REGIONAL REVIEW NOTIFICATION

ARC REVIEW CODE: R1805173

Name of Proposal: 1060 Hollowell (DRI 2815)

Review Type: DRI

PROJECT: 04/26/2018
 PROJECT NO. 013108000
 SHEET NUMBER DRI-1

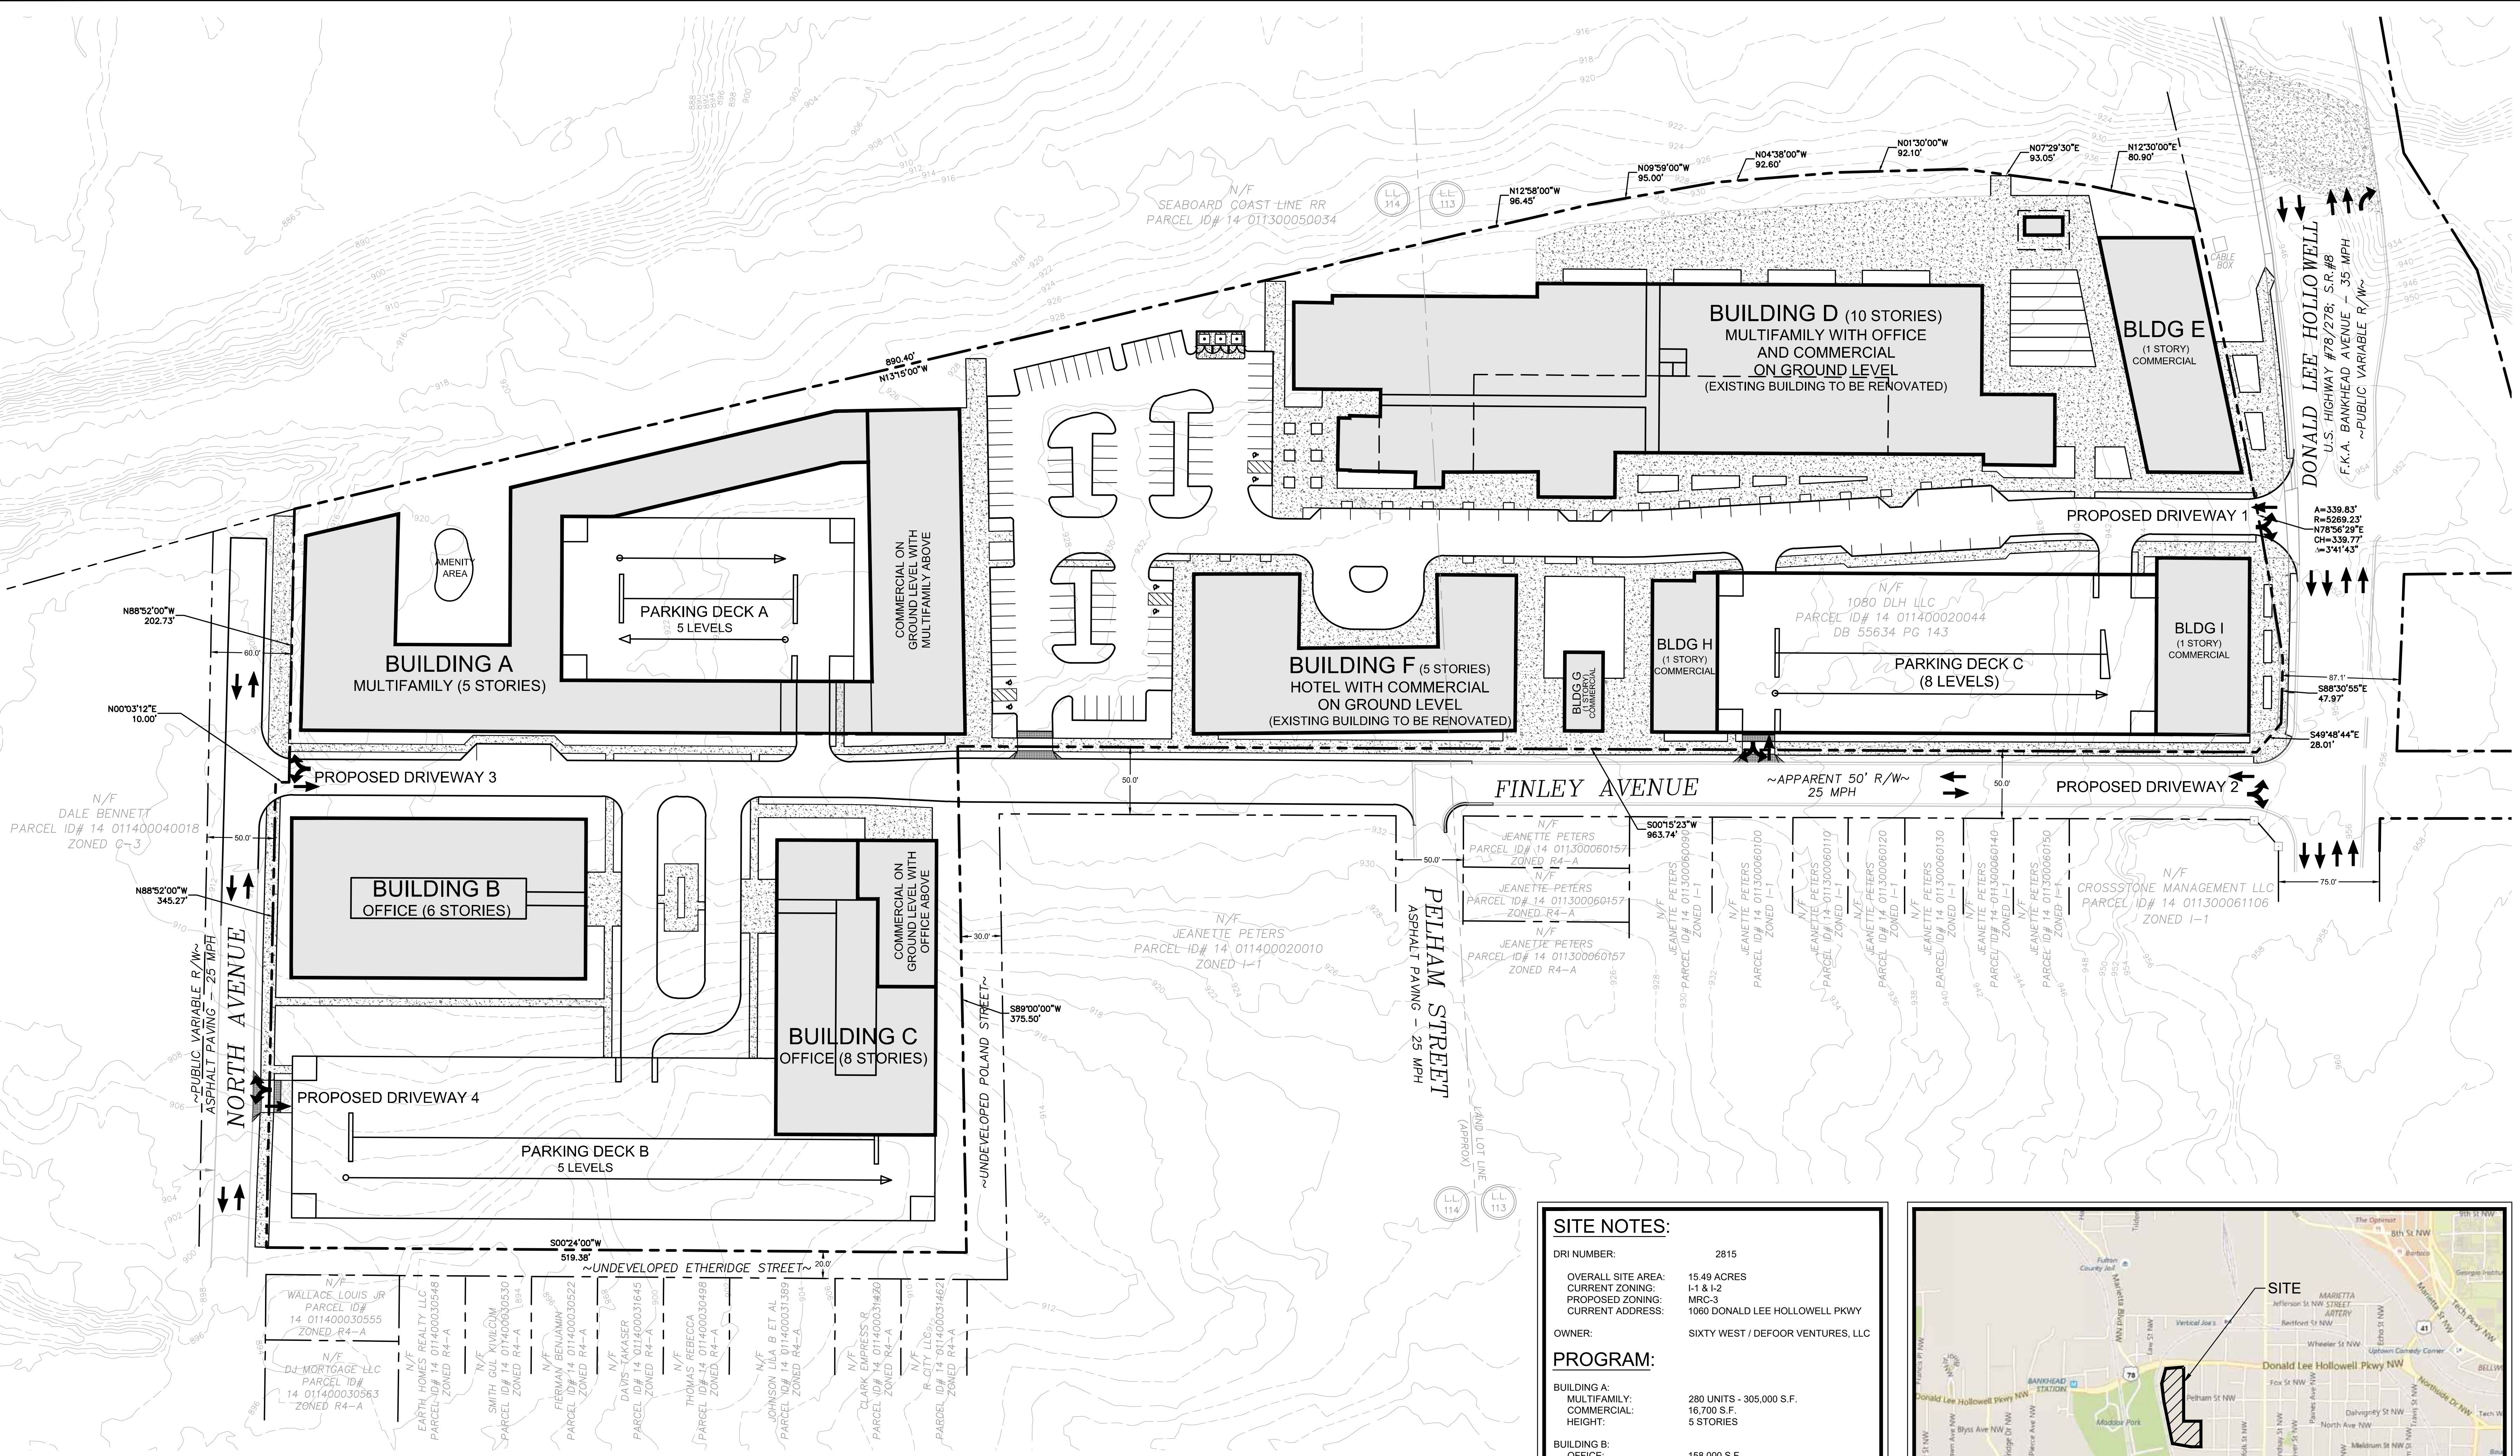
NOTE: The site plan received from the applicant, attached to this report, shows Driveway 1 (on Hollowell Pkwy.) as a full-movement driveway. This is in error. Driveway 1 is intended as a right-in/right-out only (RIRO) driveway and was analyzed as such in the traffic study required for GRTA's DRI review. A revised site plan from the applicant has been requested and will be included in the Final Report at the conclusion of ARC's review, at the latest. The projected buildout year for this DRI is 2020. The trigger for this DRI review is a rezoning application.

The site plan does not depict stub outs to adjacent parcels however adjacent parcels may be accessed by local roadways.

The development proposes pedestrian facilities internal to the site and along adjacent roadways connecting to existing facilities.
